SUNDRY NOTICES AND REPORTS ON WELLS

PLU Ross Ranch 28-25-30 USA #1H

BOPCO, L.P. respectfully requests to amend point 4 Pressure Control Equipment in the original APD as attached.

POINT 4: PRESSURE CONTROL EQUIPMENT (SEE ATTACHED DIAGRAM 2)

**13-5/8" X 3-M BOPE (2 Rams and Rotating Head) &
Closed Loop System Equipment Schematic
Diagram 2**

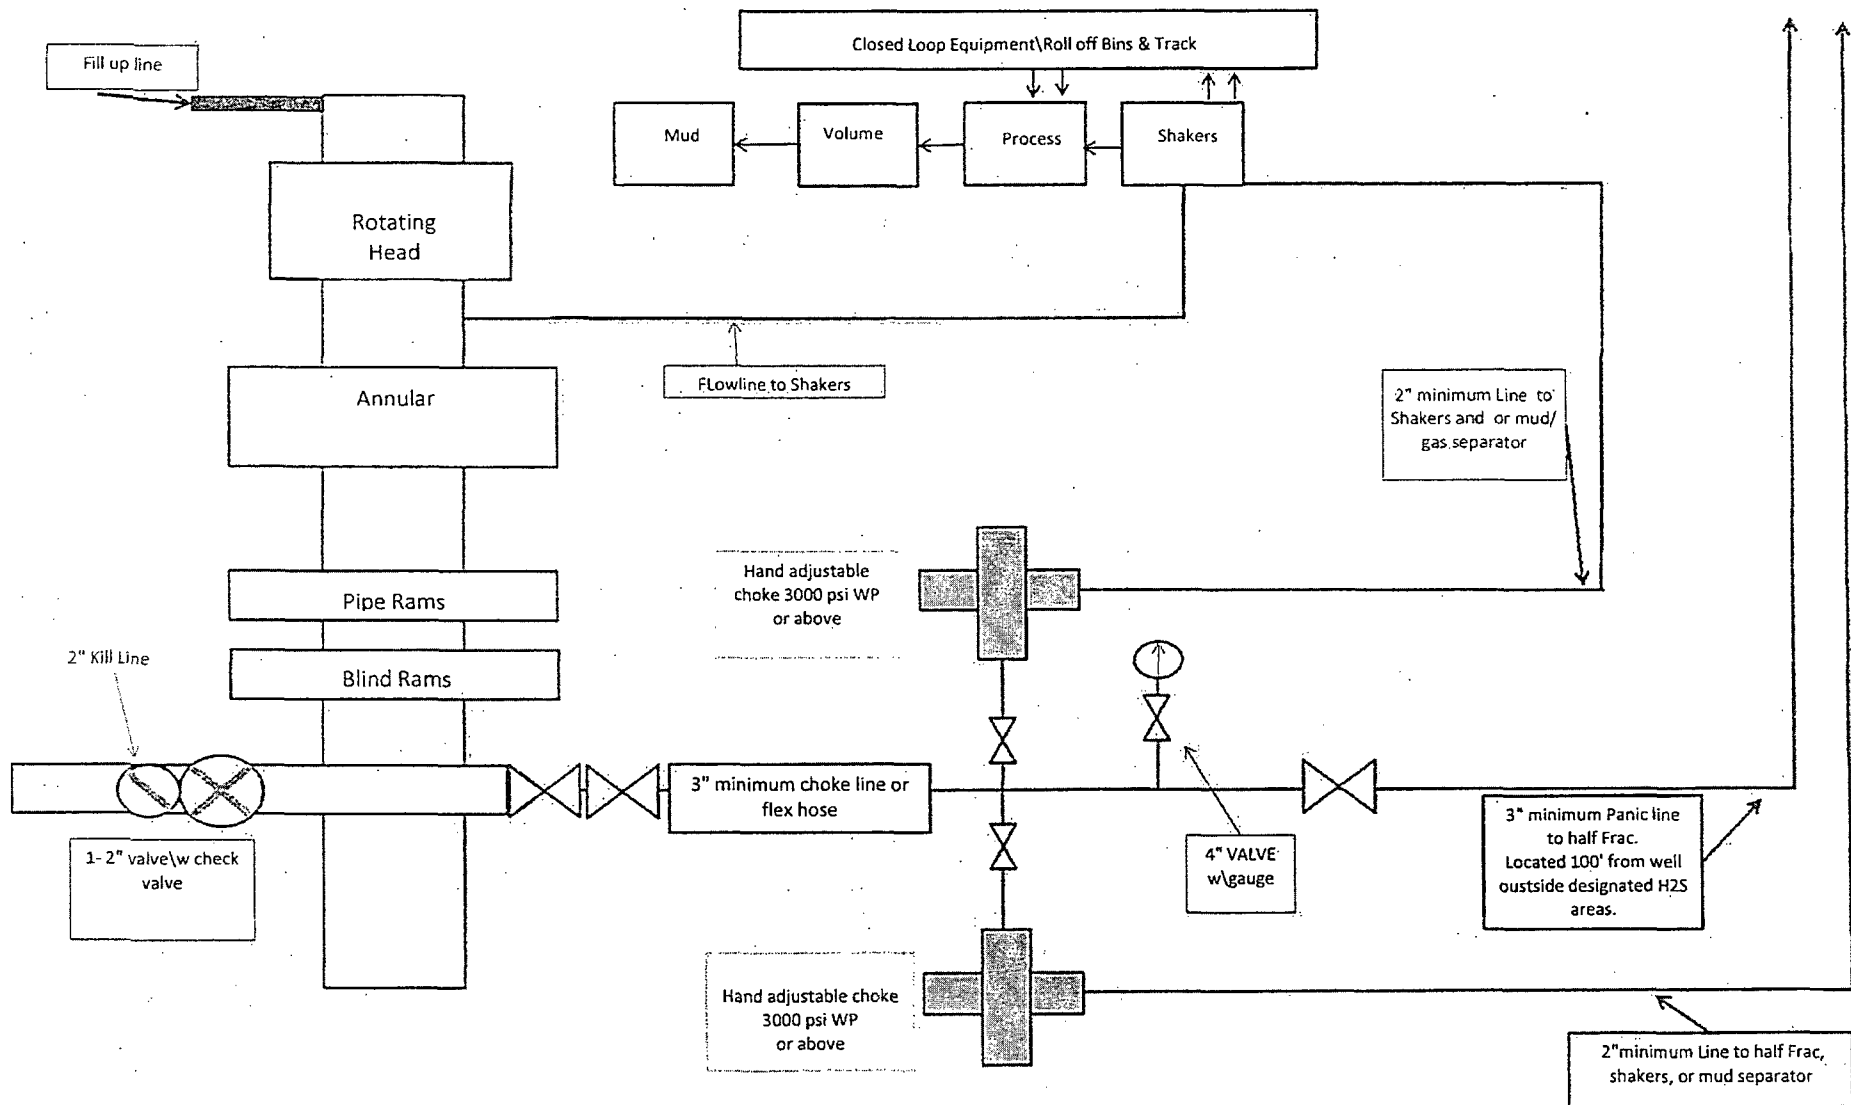
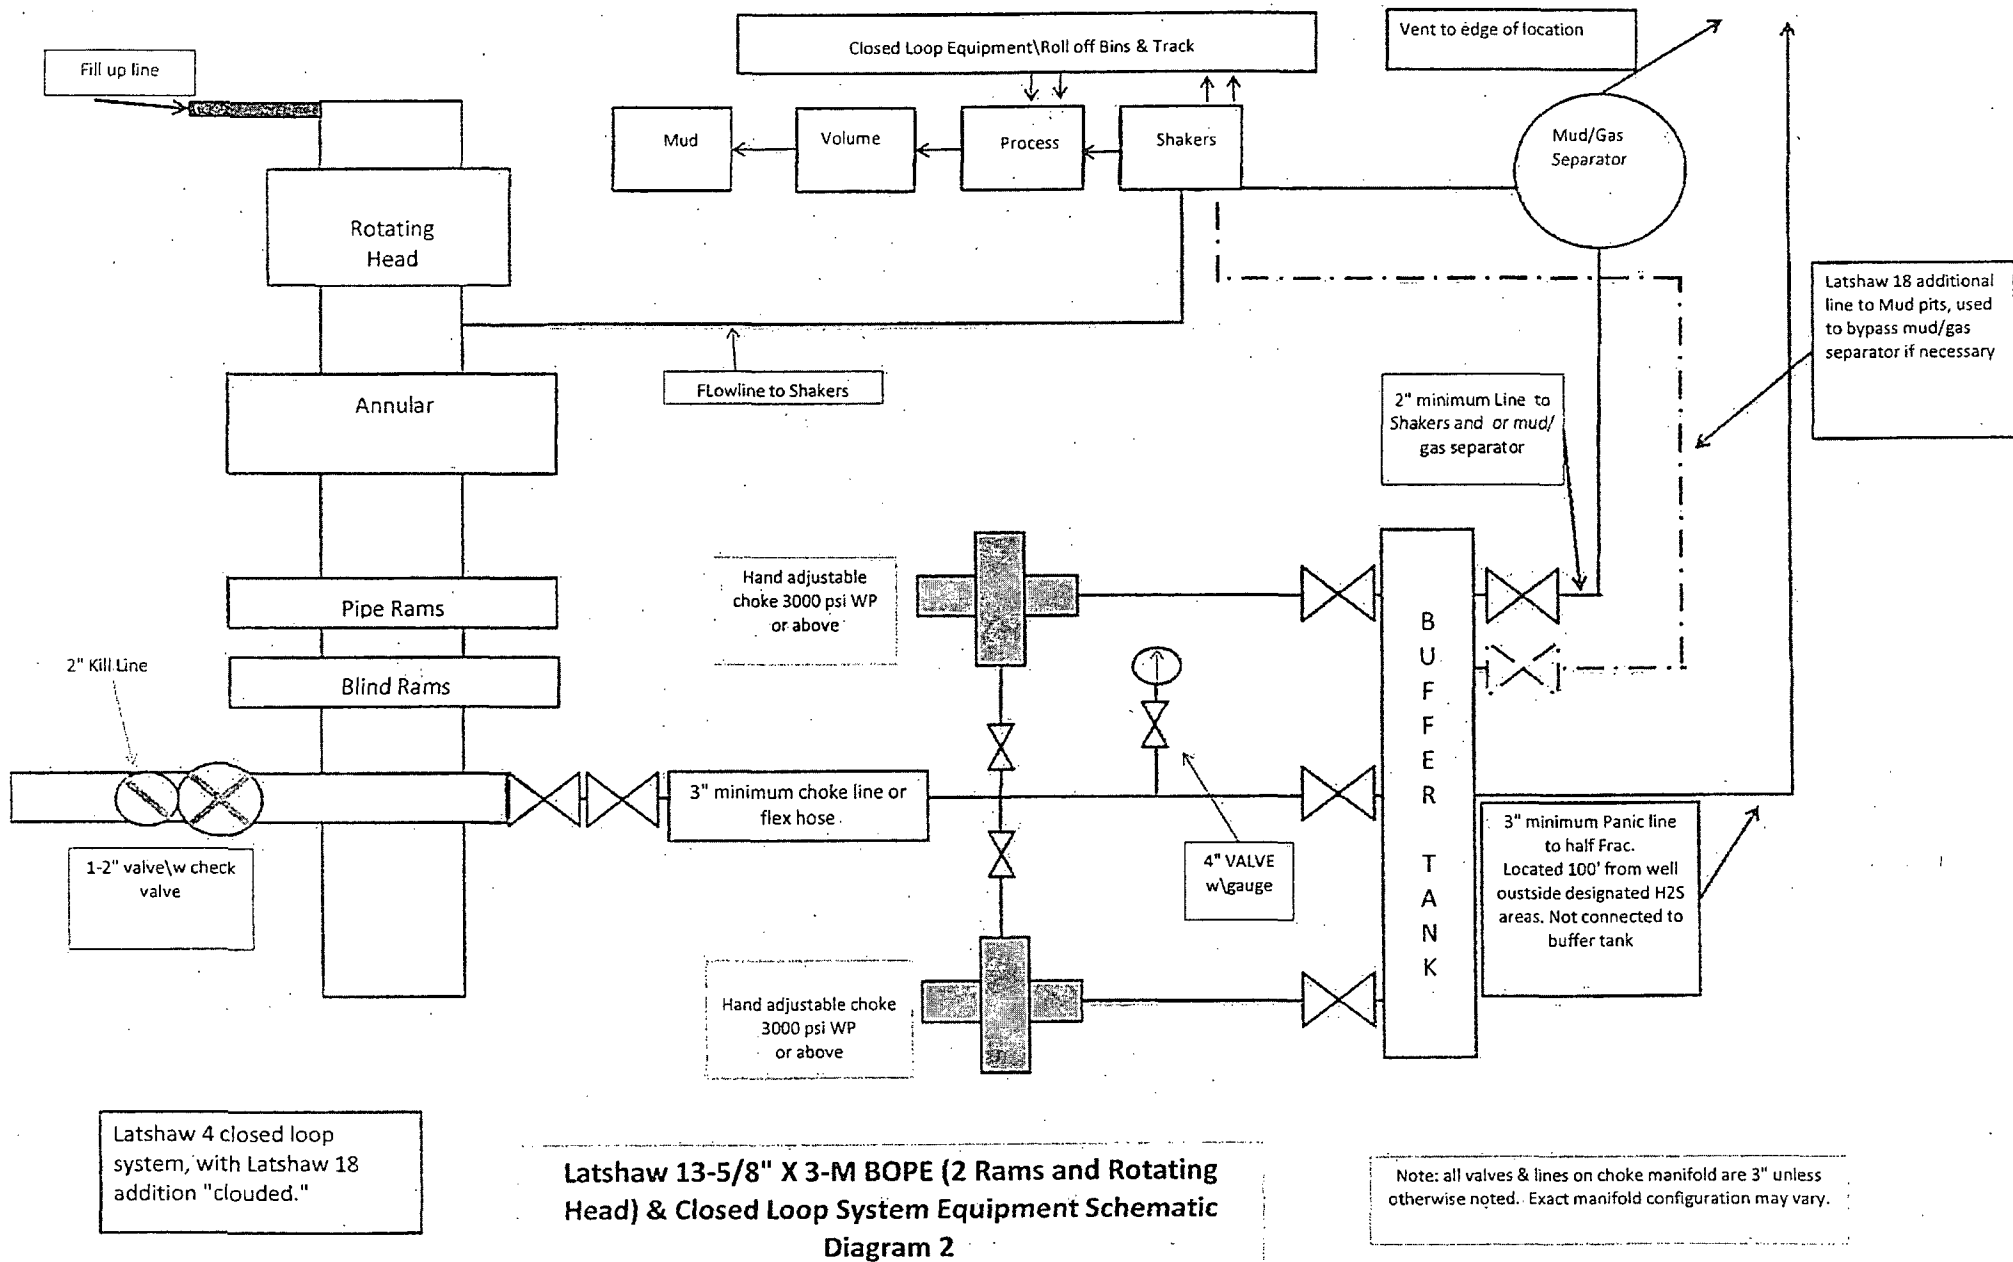
After running the 13-3/8" surface casing, a 13-5/8" BOP/BOPE system with a minimum rating of 3M will be installed, used, maintained and tested as per Onshore Order 2. In addition to the high pressure test, a low pressure (250-300 psig) test will be performed.

After running the 8-5/8" intermediate casing, a 13-5/8" or 11" BOP/BOPE system with a minimum rating of 3M will be installed on the 8-5/8" intermediate casing spool (7-7/8" open hole), used, maintained and tested as per Onshore Order 2. In addition to the high pressure test, a low pressure (250-300 psig) test will be performed.

**13-5/8" X 3-M BOPE (2 Rams and Rotating Head) &
Closed Loop System Equipment Schematic
H2S contingency
Diagram 2**

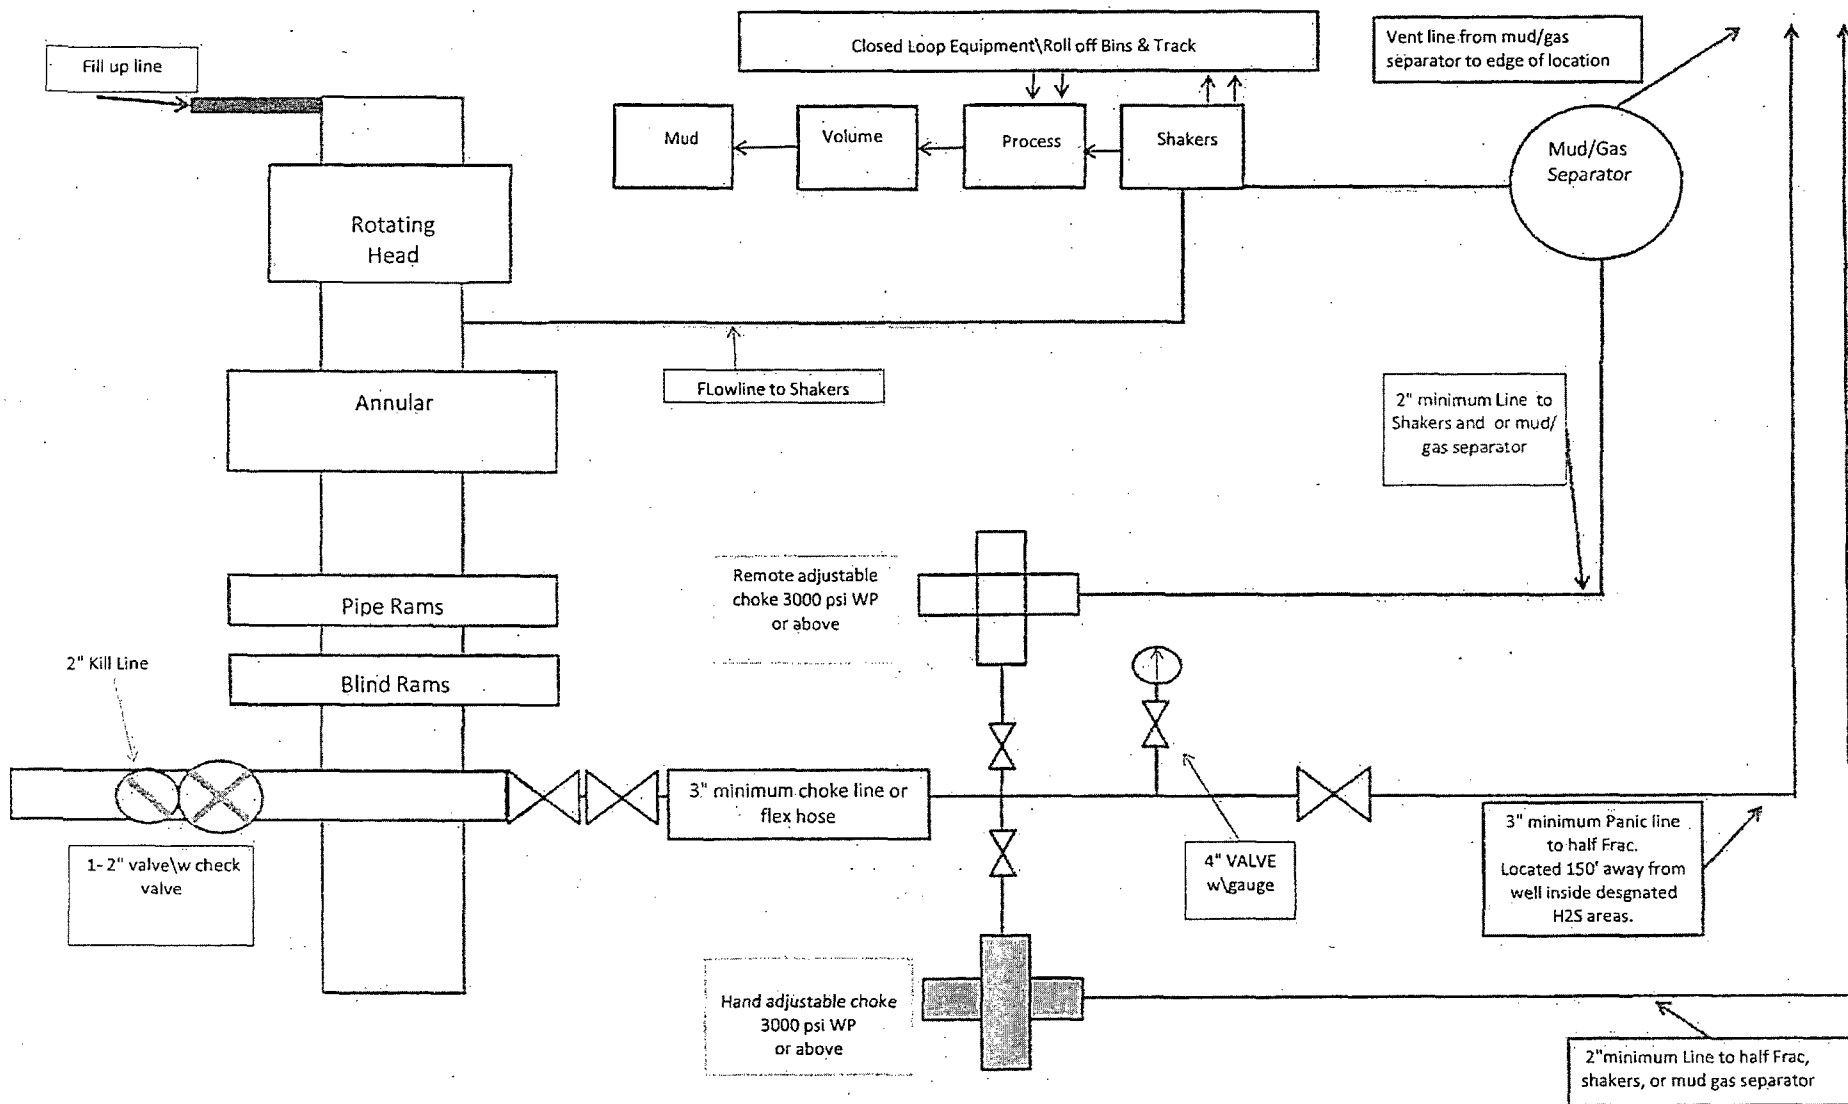
H2S contingency

H2S monitors shall be installed prior to drilling out the surface shoe. If H2S is encountered in quantities greater than 10 PPM, the well will be shut in and H2S equipment will be installed, including a flare line that will be extended pursuant to onshore oil and gas order #6.
